Product Change Notice

Issue Date: 29-January-2021

Add ASE-KH as a 2nd source wafer sort (i.e. wafer probe) site

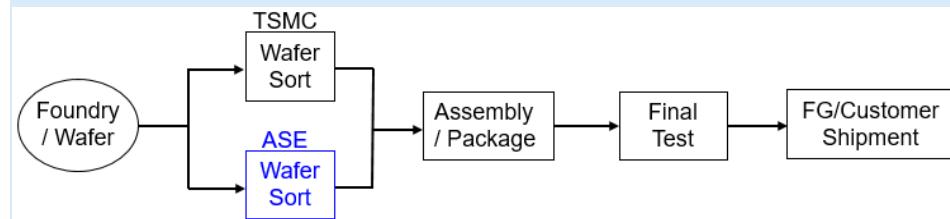
Electrical wafer sort testing is currently performed on this product at TSMC Fab 14 (Tainan, Taiwan R.O.C.). Broadcom will add ASE-KH (Kaohsiung City, Taiwan R.O.C.) as a 2nd source for wafer sort. There is no change to Foundry, Assembly or Final Test – see updated flow below.
